Product Change Notification

1. ECR #: 26-57084-5
Notification #: 840

- ERF8-EMX

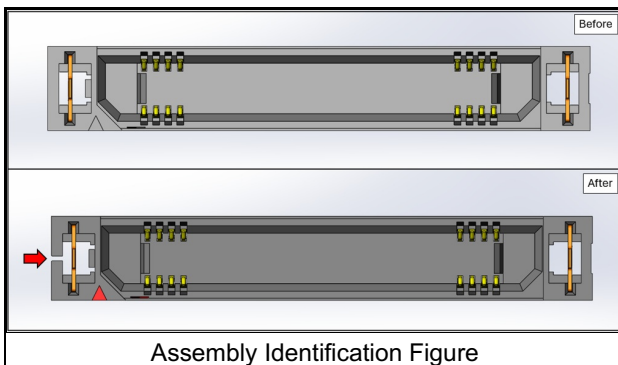
Adding a small cutout feature on one end of the housing on the side opposite of the current recess.

There will be a cutout feature visible on the outside of the housing on the opposite side of the recess.
